## ZONING ORDINANCE MODERNIZATION (ZMOD)

## DESCRIPTION OF THE APPLICATION

The CDP/FDP entitled “7700 Leesburg Pike” was prepared by Walter L. Phillips Incorporated, and consists of 34 sheets dated December 15, 2020, as revised through October 8, 2021. A reduced copy of the CDP/FDP is located at the front of the staff report.

Figure 4: Vehicular Circulation

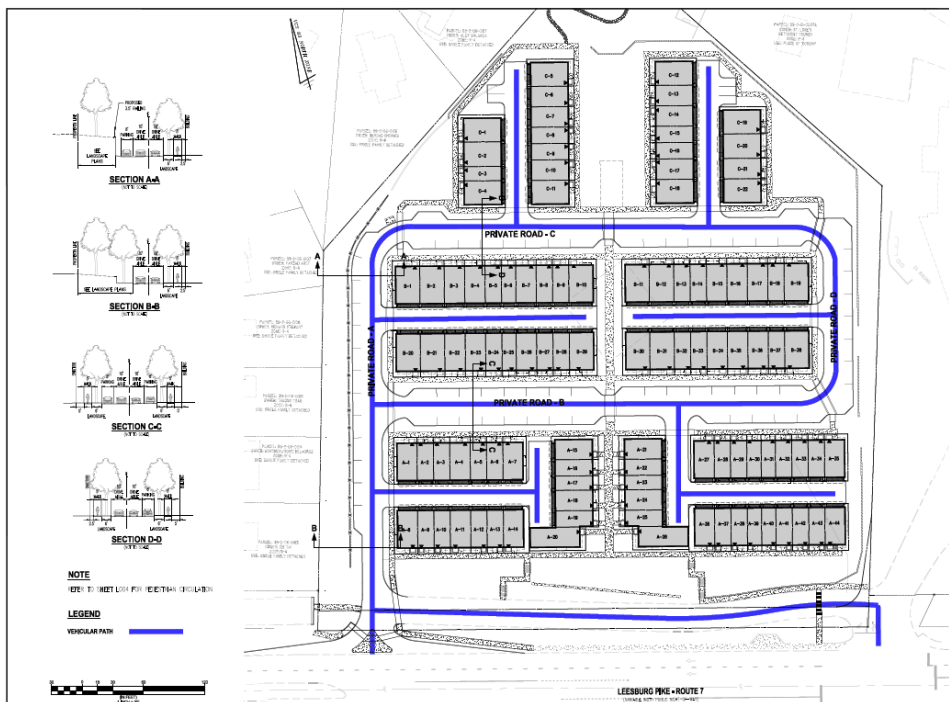
During the review of this application, staff identified issues with the maneuverability of vehicles and trash trucks to turn around in the proposed alleys. While the applicant has worked to address these concerns, staff continues to recommend that additional turnaround space be provided for vehicles in the alleys. The Autoturn analysis provided demonstrates that any vehicle not able to pull into a garage would be forced to drive in reverse out of the alley to return to the internal site streets, which could pose unnecessary safety and operational challenges.

However, as discussed earlier in this report, according to the Autoturn analysis provided by the applicant, any vehicle not able to pull into a garage would be forced to reverse out of the alley. Staff would continue to urge the applicant to provide additional turning areas within the alleys to address this issue.

Figure 5: Comprehensive Plan recommended public road

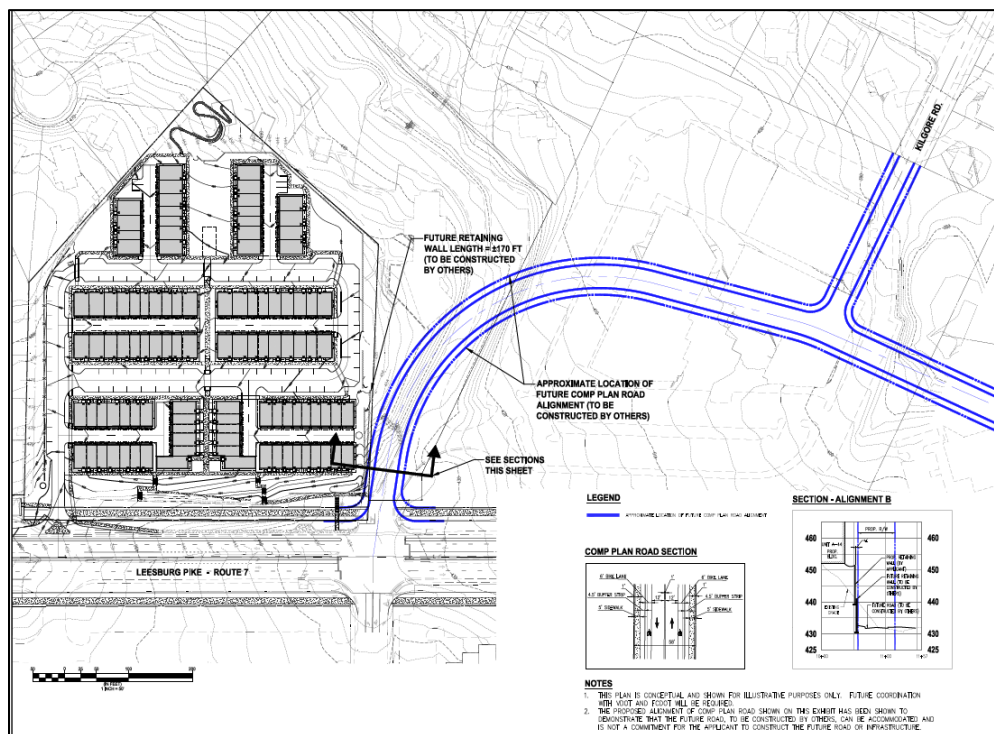
The Comprehensive Plan for this area recommends the construction of a future two-lane local road alignment to the east of the subject property as seen in Figure 5 below. The applicant has proffered to provide the necessary right-of-way (ROW) dedication and construction easements for the future construction of this road alignment; staff would note that reservation for future dedication is appropriate in this instance given the lack of specificity on the design and timing of this road.

Unfortunately, as proposed, the applicant's proffer includes a 30-year expiration for this commitment to provide this future dedication and associated easements. This connection is currently unfunded and the timeline for the construction of this future road is unknown. Staff is concerned that this timing limitation could result in future challenges for implementation of the Comprehensive Plan. Furthermore, staff does not believe that this sunset clause is necessary as the applicant has included a proffer which would

allow for this reservation to be vacated in the future if necessary. This issue remains unresolved.

The applicant is also requesting a modification of the future Comprehensive Road planned to the east of the site. The applicant has proffered a commitment to reserve ROW for future dedication and easements for the construction of the Comprehensive Plan Road. Staff would note that reservation for future dedication is appropriate in this instance given the lack of specificity on the design and timing of this road. However, the applicant has added a 30-year sunset clause for this reservation. As discussed earlier in this report, staff does not support the sunset clause, and if this is included, staff does not support this modification request.
